BCA COMPLIANCE CAPABILITY REPORT

PREMISES
56-60 Burns Bay Road
Lane Cove

DATE
16 May 2019

Project: Proposed mixed-use residential building – 56-60 Burns Bay Road, Lane Cove

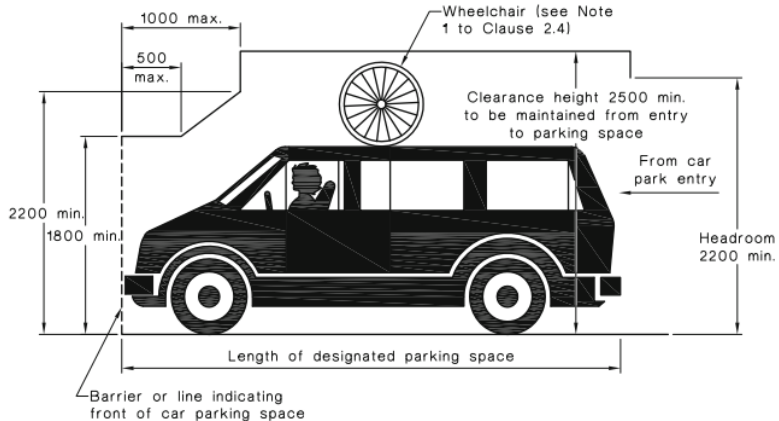
Item	Comment
<i>Handrails</i>	<p>Handrail design and construction shall strictly comply with the requirements specified in NCC Clause D2.17.</p> <p>Generally, handrails must be provided to all stairways at a height not less than 865mm measured above the nosings of the stair treads.</p>
<i>Protection of openable windows</i>	<p>Window openings where the floor is more than 2m above the surface beneath must be protected in accordance with NCC Clause D2.24 in the bedrooms for the class 2 part of the building.</p> <p>It is noted that all bedroom windows will have restrictors to have 125mm spacing.</p>
